**TOWN OF HUDSON
PLANNING BOARD
PUBLIC MEETING
TOWN OF HUDSON, NH
AUGUST 13, 2014**

- A. Derry Street Retail LLR (Hogan) Map 165/Lots 145 & 146
SB# 06-14 66 & 68 Derry Street

- B. Derry Street Retail Site Plan (Hogan) Map 165/Lot 145
SP# 10-14 66 Derry Street

PLAN UNDER REVIEW ENTITLED: “Non-Residential Site Plan Derry Street Retail, Map 165 Lots 145 & 146, 66 & 68 Derry St., Hudson, NH, prepared by Keach-Nordstrom Associates, Inc., dated: July 7, 2014 (no revision date), consisting of Sheets 1 - 20 and Notes 1 – 30 on Sheet 1 (said plans are attached hereto).

DATE: JULY 7, 2014 SCALE: 1" = 30'
PROJECT NO: 13-0508-2 SHEET 5 OF 20

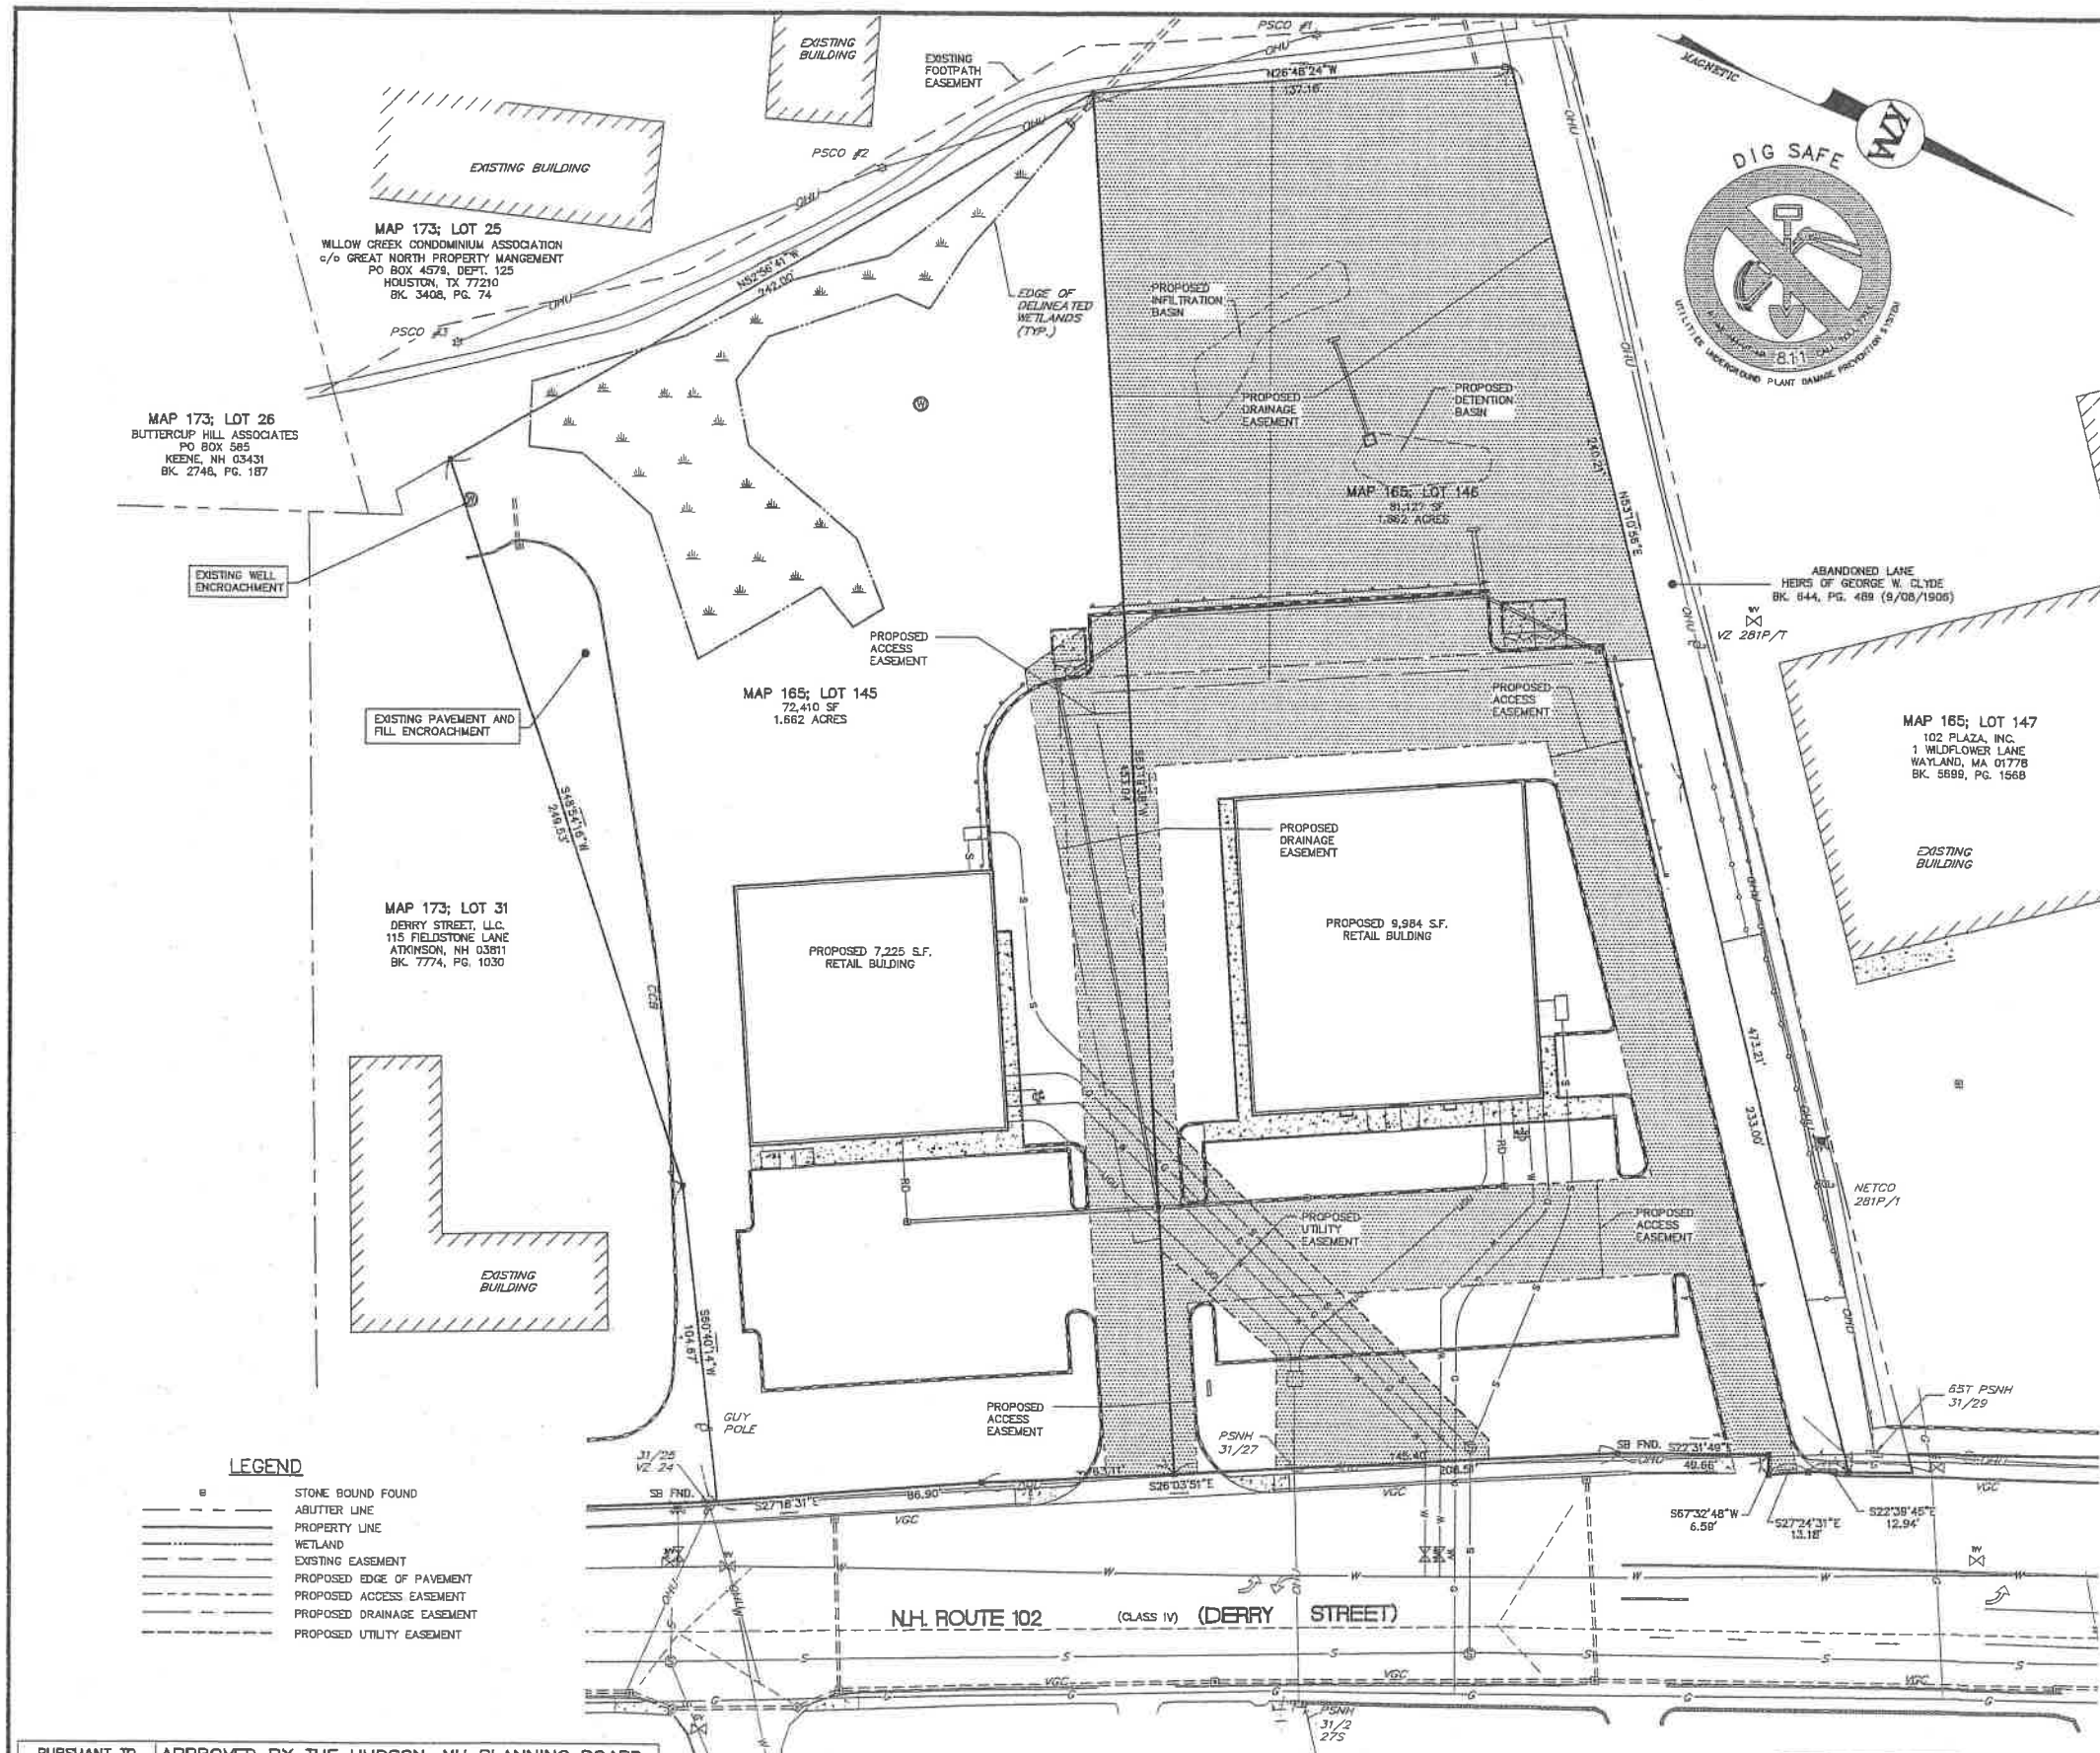
E) Relative to the main driveway being shared, cross easements will have to be drafted and favorably recommended by Town Counsel. The same holds true for the drain and utility easements concerning both development lots, as shown on Sheet 5 of 20 – Easement Plan.

DATE: JULY 7, 2014 SCALE: 1" = 30'
 PROJECT NO: 13-0509-2 SHEET 6 OF 20

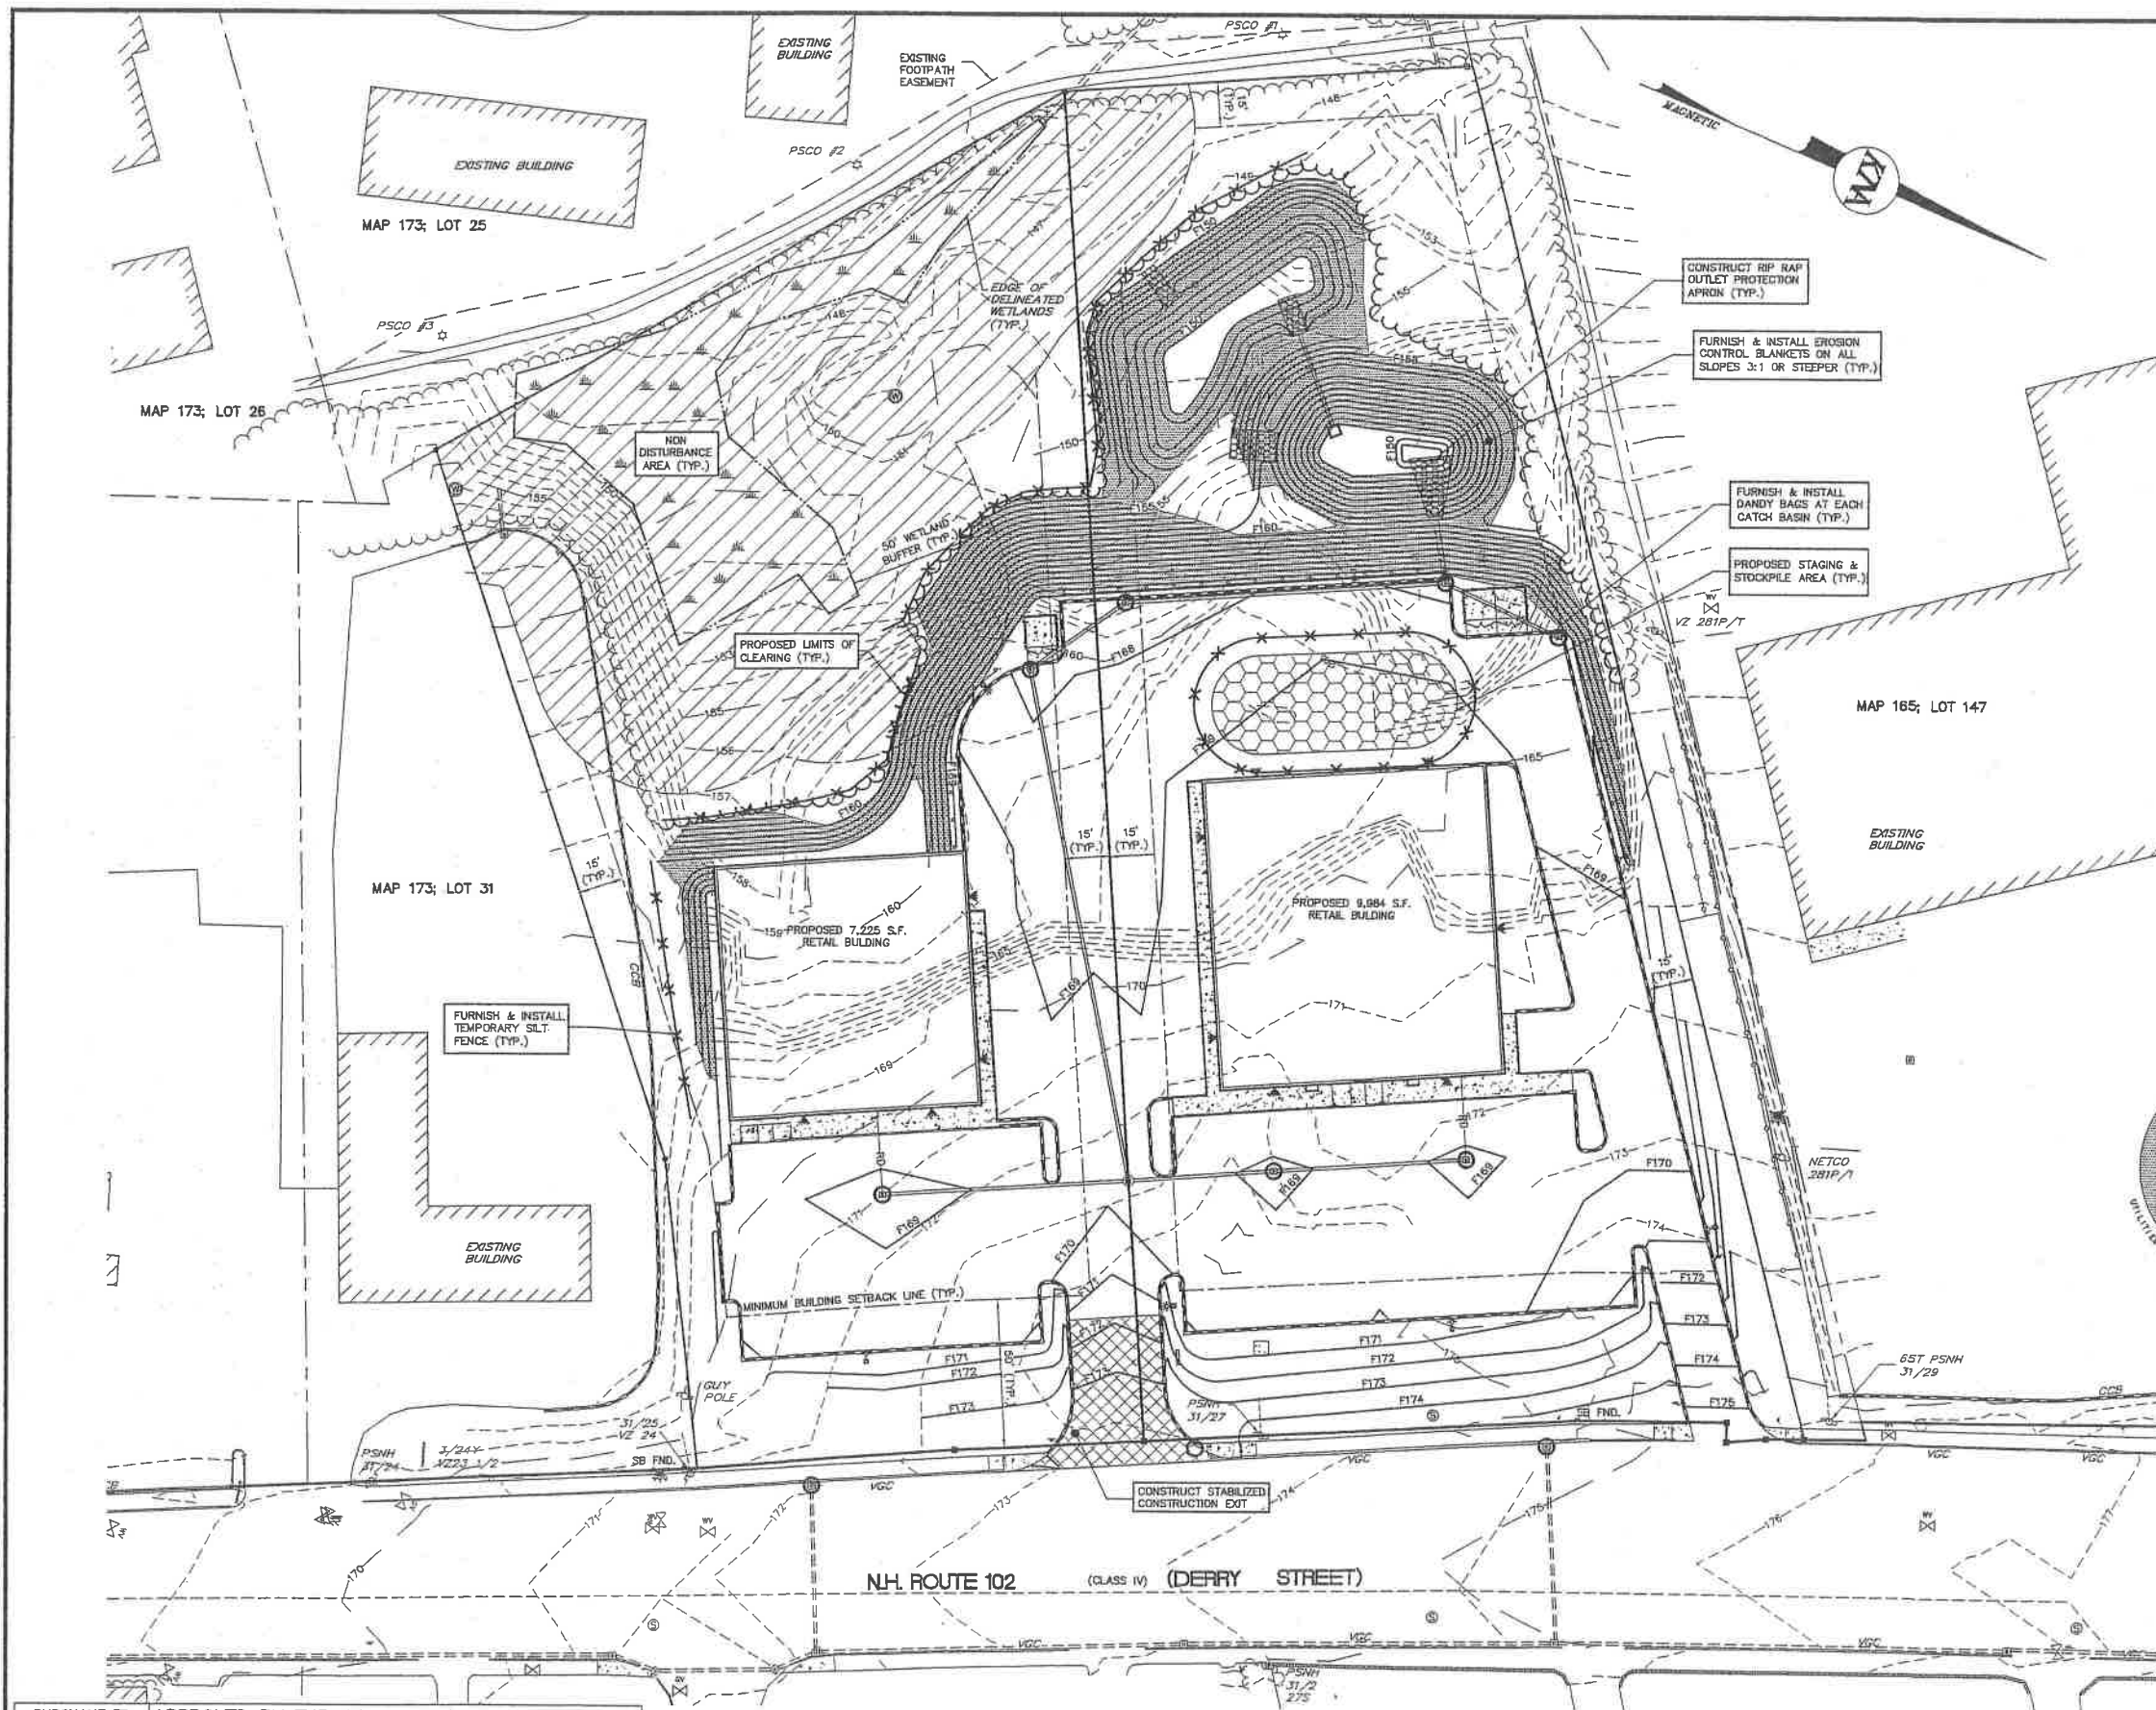
- e. The applicant should coordinate the discrepancy between the contour labels on the Grading and Drainage Plan (Sheet 6) within Detention Pond #1 and Infiltration Pond #1 as they do not correspond with the elevations utilized within the AoT Permit for the related calculations.

- e. The applicant should coordinate the discrepancy between the contour labels on the Grading and Drainage Plan (Sheet 6) within Detention Pond #1 and Infiltration Pond #1 as they do not correspond with the elevations utilized within the AoT Permit for the related calculations.

Notes regarding the bottom of the detention pond and infiltration pond have been added to sheet 6. These elevations are consistent with the NHDES BMP worksheets and our HydroCAD model.
